STREAM ROCKWALL - 2
 PREPARED FOR
WESTCORE BRAVO, LLC
 ROCKWALL, TEXAS

SITE PLAN
 SHEET NUMBER
SP-1

SP2024-045: Amended Site Plan for 1351 Corporate Crossing

TO: Planning and Zoning Commission
DATE: October 29, 2024
APPLICANT: Chris Lewis; *Kimley-Horn and Associates, Inc.*
CASE NUMBER: SP2024-045; *Amended Site Plan for 1351 Corporate Crossing (SCP Distribution Center)*

FIGURE 1. APPROXIMATE LOCATION AND VISIBILITY OF THE PROPOSED OUTSIDE STORAGE AREA FROM CORPORATE CROSSING.

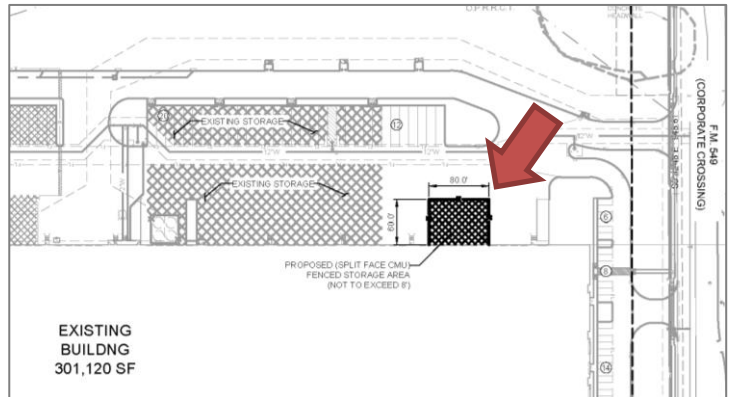
On September 14, 2021, the Planning and Zoning Commission approved a site plan [Case No. SP2021-024] to allow the construction of a 301,120 SF Warehouse/Distribution Center on the subject property. Following the construction of the Warehouse/Distribution Center, the Planning and Zoning Commission approved two (2) amended site plans, [1] [Case No. SP2023-006] to allow ~78,500 SF (~10% of the total impervious area) of outside storage and eight (8) silos, and [2] [Case No. SP2024-027] to allow ~48,000 SF (~6.10% of the total impervious area) of outside storage and four (4) silos on the subject property. This equates to a total of 12 silos and ~126,500 SF (~16.10% of the total impervious area) of outside storage. In February 2023 a fence permit [Permit No. COM2024-598] was submit to the Building Inspection Department requesting to construct an eight (8) foot wrought iron fence for outside storage. Staff informed the applicant that the proposed outside storage was not delineated on the approved site plan and an amended site plan would be required. Based on staff's comment, on May 17, 2024 the applicant submitted a development application requesting approval of an *Amended Site Plan* to allow a 60-foot by 80-foot (*i.e.* 4,800 SF) outside storage area. Due to visibility concerns that the Planning and Zoning Commission expressed, this request was ultimately withdrawn by the applicant in order to explore other screening options. Following this, on October 18, 2024, the applicant submitted a new amended site plan application.

According to Subsection 01.05(E), *Screening Standards*, of Article 05, *District Development Standards*, of the Unified Development Code (UDC), "(o)outside storage of materials or vehicles shall be screened from all public streets, any residential zoning district or residentially used property, and parks and open space that abuts or is directly across a public street or alley from the subject property." In addition, Subsection 01.05(E) states that the associated screening "...must be at least one (1) foot taller than the material or vehicles being stored and shall be achieved using a masonry wall (*excluding tilt wall or concrete masonry units [CMU] unless otherwise approved by the Planning and Zoning Commission*) and Canopy Trees on 20-foot centers..."; however, the Planning and Zoning Commission may approve alternative landscape screening methods. In this case, the applicant is requesting to screen a 60-foot by 80-foot (*i.e.* 4,800 SF) outside storage area, with an eight (8) foot split face CMU screening wall, without canopy trees on 20-foot centers. Based on this, the applicant is requesting an exception to this requirement. In addition, the applicant has indicated that the "...outside storage area will consist of palletized crates of

According to Subsection 09.01, *Exceptions to the General Standards*, of Article 11, *Development Applications and Review Procedures*, of the Unified Development Code (UDC), "...an applicant may request the Planning and Zoning Commission grant an exception to the provisions contained in the Unified Development Code (UDC), where unique or extraordinary conditions exist or where strict adherence to the technical requirements of the Unified Development Code (UDC) would create an undue hardship." In addition, the code requires that applicants provide compensatory measures that directly offset the requested exception. In this case, the applicant is not providing any compensatory measures to offset the requested exception to the outside storage screening requirements. With this being said, requests for exceptions to the general standards are discretionary decisions for the Planning and Zoning Commission. Staff should also note that a supermajority vote (e.g. six [6] out of the seven [7] commissioners) -- with a minimum of four (4) votes in the affirmative -- is required for the approval of an exception. If the Planning and Zoning Commission chooses to approve the applicant's Amended Site Plan to allow outside storage on the *subject property* as delineated on the site plan, then staff would propose the following conditions of approval:

- (1) All outside storage may not exceed eight (8) feet in total height and/or extend above the eight (8) foot split face CMU wall; and,
- (2) Any construction resulting from the approval of this Site Plan shall conform to the requirements set forth by the Unified Development Code (UDC), the International Building Code (IBC), the Rockwall Municipal Code of Ordinances, city adopted engineering and fire codes and with all other applicable regulatory requirements administered and/or enforced by the state and federal government.

FIGURE 1. APPROXIMATE LOCATION AND VISIBILITY OF THE PROPOSED OUTSIDE STORAGE AREA FROM CORPORATE CROSSING.

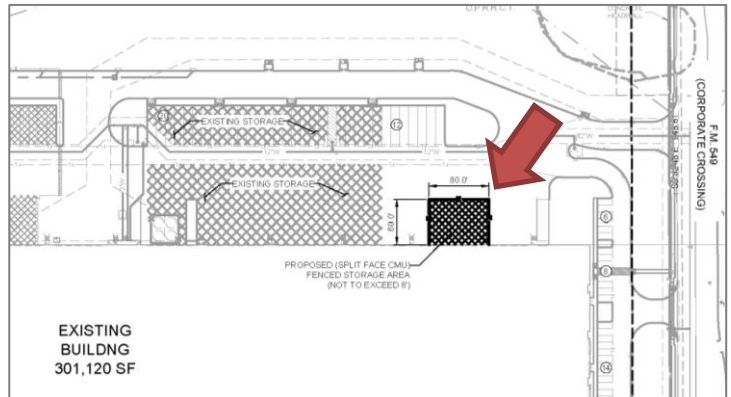
On September 14, 2021, the Planning and Zoning Commission approved a site plan [Case No. SP2021-024] to allow the construction of a 301,120 SF Warehouse/Distribution Center on the subject property. Following the construction of the Warehouse/Distribution Center, the Planning and Zoning Commission approved two (2) amended site plans, [1] [Case No. SP2023-006] to allow ~78,500 SF (~10% of the total impervious area) of outside storage and eight (8) silos, and [2] [Case No. SP2024-027] to allow ~48,000 SF (~6.10% of the total impervious area) of outside storage and four (4) silos on the subject property. This equates to a total of 12 silos and ~126,500 SF (~16.10% of the total impervious area) of outside storage. In February 2023 a fence permit [Permit No. COM2024-598] was submitted to the Building Inspection Department requesting to construct an eight (8) foot wrought iron fence for outside storage. Staff informed the applicant that the proposed outside storage was not delineated on the approved site plan and an amended site plan would be required. Based on staff's comment, on May 17, 2024 the applicant submitted a development application requesting approval of an *Amended Site Plan* to allow a 60-foot by 80-foot (*i.e.* 4,800 SF) outside storage area. Due to visibility concerns that the Planning and Zoning Commission expressed, this request was ultimately withdrawn by the applicant in order to explore other screening options. Following this, on October 18, 2024, the applicant submitted a new *Amended Site Plan* application. At the October 29, 2024 Planning and Zoning Commission meeting, the applicant requested a two (2) week extension in order to provide an exhibit of the proposed outside storage enclosure. This established the applicant's new action date as November 12, 2024; however, the applicant was unable to provide the additional exhibit, and subsequently extended their request an additional two (2) weeks to the November 26, 2024 Planning and Zoning Commission meeting.

According to Subsection 01.05(E), *Screening Standards*, of Article 05, *District Development Standards*, of the Unified Development Code (UDC), "(o)outside storage of materials or vehicles shall be screened from all public streets, any residential zoning district or residentially used property, and parks and open space that abuts or is directly across a public street or alley from the subject property." In addition, Subsection 01.05(E) states that the associated screening "...must be at least one (1) foot taller than the material or vehicles being stored and shall be achieved using a masonry wall (*excluding tilt wall or concrete masonry units [CMU] unless otherwise approved by the Planning and Zoning Commission*) and Canopy Trees on 20-foot

centers...”; however, the Planning and Zoning Commission may approve alternative landscape screening methods. In this case, the applicant is requesting to screen a 60-foot by 80-foot (*i.e.* 4,800 SF) outside storage area, with an eight (8) foot split face CMU screening wall, without canopy trees on 20-foot centers. Based on this, the applicant is requesting an exception to this requirement. In addition, the applicant has indicated that the “...outside storage area will consist of palletized crates of stone, pavers, bagged sand, PVC pipe (3” or less), and pre-cast concrete equipment pads. There will be no chemicals stored in the yard.” If approved this would increase the outside storage on the subject property to ~131,300 SF (~16.71% of the total impervious area). Based on the Planning and Zoning Commissions concerns from the October 29, 2024 meeting (*i.e.* the appearance of the enclosure and the direction the enclosure would be loaded), the applicant has provided an exhibit depicting the enclosure and the existing landscaping at a mature state. In addition, the provided exhibit indicates that the loading area will face east and will have direct visibility from Corporate Crossing, but that they will be using a slated steel material that will impair visibility of the materials when the gate is closed.

According to Subsection 09.01, *Exceptions to the General Standards*, of Article 11, *Development Applications and Review Procedures*, of the Unified Development Code (UDC), “...an applicant may request the Planning and Zoning Commission grant an exception to the provisions contained in the Unified Development Code (UDC), where unique or extraordinary conditions exist or where strict adherence to the technical requirements of the Unified Development Code (UDC) would create an undue hardship.” In addition, the code requires that applicants provide compensatory measures that directly offset the requested exception. In this case, the applicant is not providing any compensatory measures to offset the requested exception to the outside storage screening requirements. With this being said, requests for exceptions to the general standards are discretionary decisions for the Planning and Zoning Commission. Staff should also note that a supermajority vote (*e.g.* six [6] out of the seven [7] commissioners) -- with a minimum of four (4) votes in the affirmative -- is required for the approval of an exception. If the Planning and Zoning Commission chooses to approve the applicant’s Amended Site Plan to allow outside storage on the *subject property* as delineated on the site plan, then staff would propose the following conditions of approval:

- (1) All outside storage may not exceed eight (8) feet in total height and/or extend above the eight (8) foot split face CMU wall; and,
- (2) Any construction resulting from the approval of this Site Plan shall conform to the requirements set forth by the Unified Development Code (UDC), the International Building Code (IBC), the Rockwall Municipal Code of Ordinances, city adopted engineering and fire codes and with all other applicable regulatory requirements administered and/or enforced by the state and federal government.
